Product Change Notification

1. ECN #: 256936

- MEC2 - MEC2 2.0mm EDGE CARD ASSEMBLY

MEC2-DV body: the body without a stand-off; MEC2-TH body: the body with a stand-off

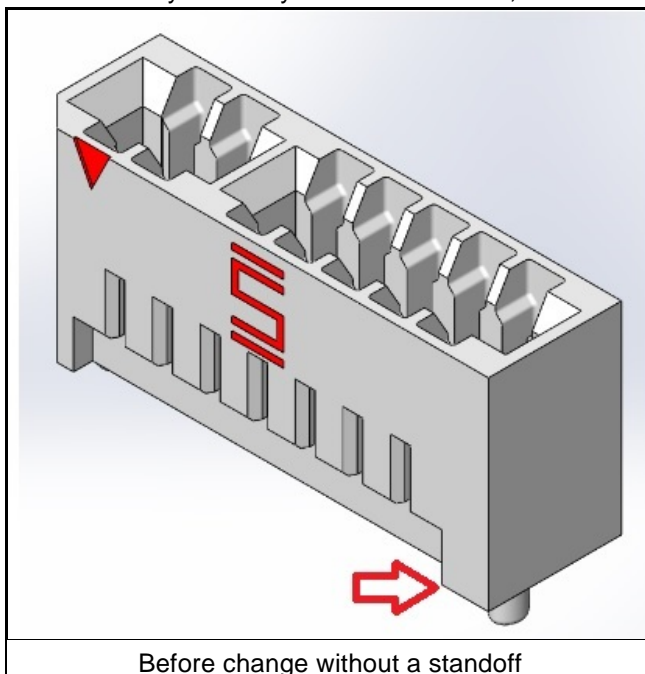
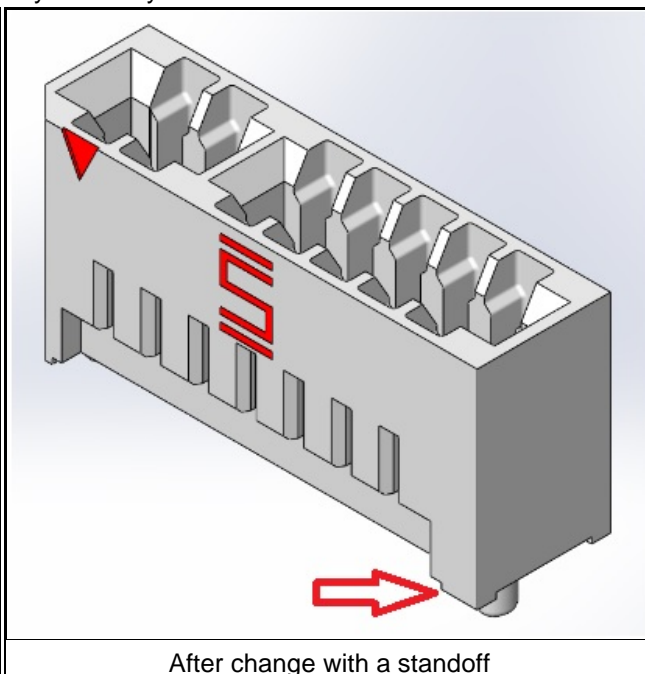
Change the body from without a stand-off to with.

Before change without a standoff

After change with a standoff

Combine both DV and TH series to use the same body to avoid mistakes. This is a running change.
